Some thoughts on Competence

Bill Harvey, Bill Harvey Associates Ltd

I am currently involved in reviewing the standards for masonry bridge repairs. This comprises 16 relatively sparsely populated drawings, each one containing too much (repeated and often contradictory) text written in large capitals. A good sample is this clause which seems to be repeated on many drawings.

2. THE VERTICAL EXTENT OF REPAIR BEING LIMITED BY SITE CONDITIONS AND POSSESSION TIMES.

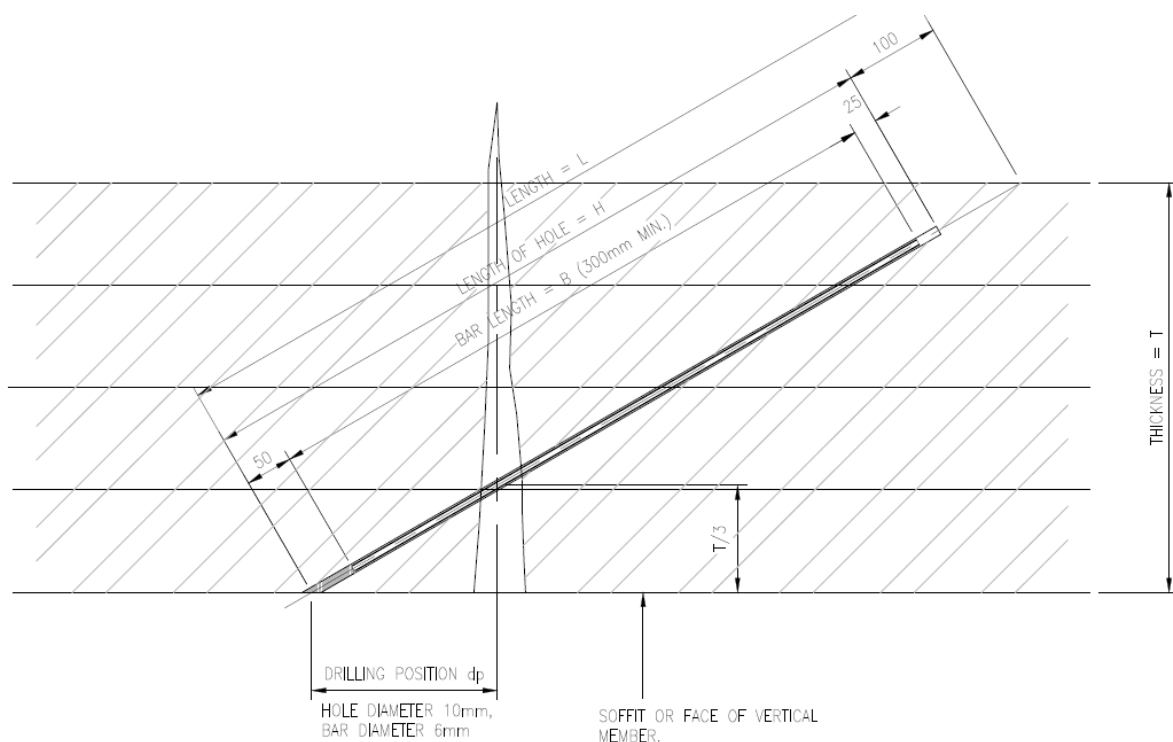
It purports to be a numbered clause but isn't even a complete sentence. We might think we know what it means but how can we be sure.

**TYPICAL SECTION AT 30° CROSS STITCHING OF
ROTATIONAL CRACK IN ARCH OR VERTICAL MEMBER**

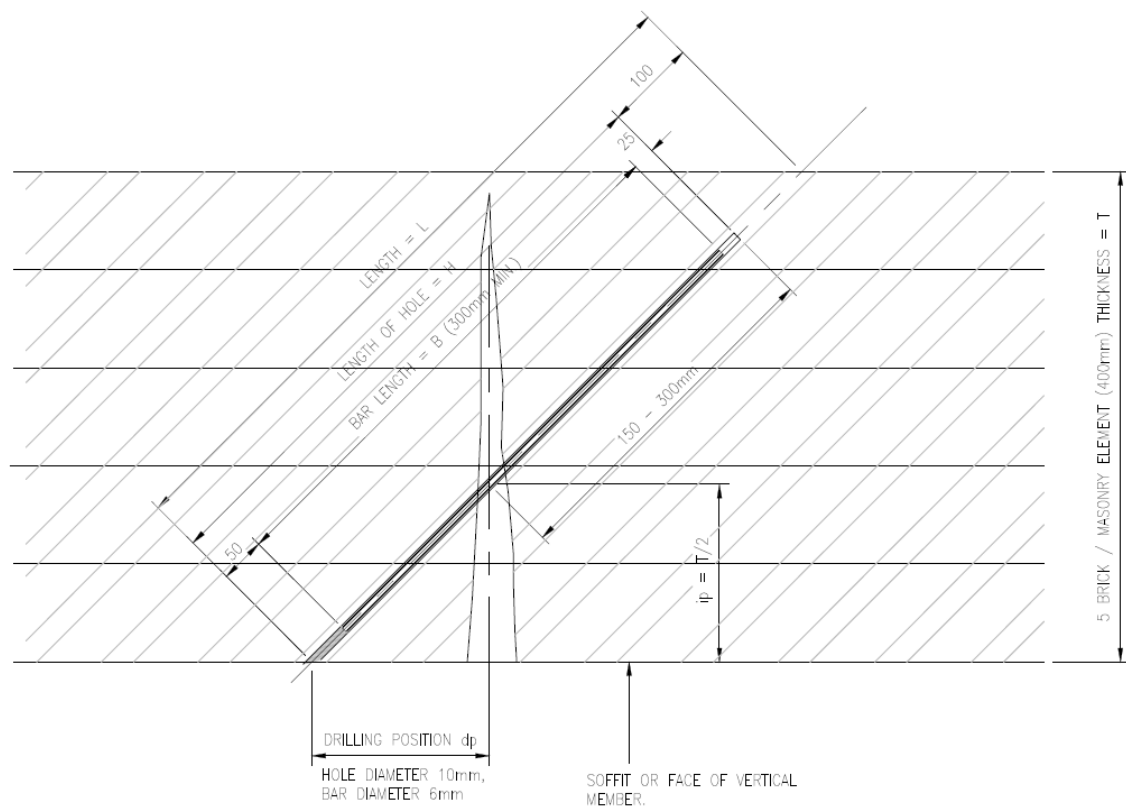
In a typical stitching operation, traditionally, a 25mm rebar is grouted into a diagonal hole through a ring. In the latest details, that bar is reduced to 6mm diameter in a 10mm hole. Further bars go in on opposite diagonals at 500mm centres. So the bar is being expected to hold a force that could not be resisted by 0.25m^2 of brickwork. It may be “strong” enough but even a 25mm bar isn’t nearly stiff enough to do anything useful. If you do set about measuring the result, you find that the deflection across the crack under live load does not change. (I know, I have done it but no one else EVER has so far as I can tell).

Then there is the fact that, at 45°, $75\text{mm} \times 1.414$ is only 106mm so the hole will only just enter the upper ring and the bar will stop 20mm short. In the 30° example, the idea that a bar anchored only 100mm in a brick can hold anything purposeful is quite laughable. It will simply pull out and probably do no further damage but not do anything that might be regarded as good.

TYPICAL SECTION AT 45° CROSS STITCHING OF SHEAR CRACK IN ARCH STRUCTURAL ELEMENT

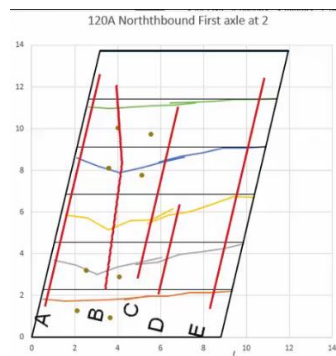
One obvious question is how does one recognise the difference between a rotation and a shear crack?
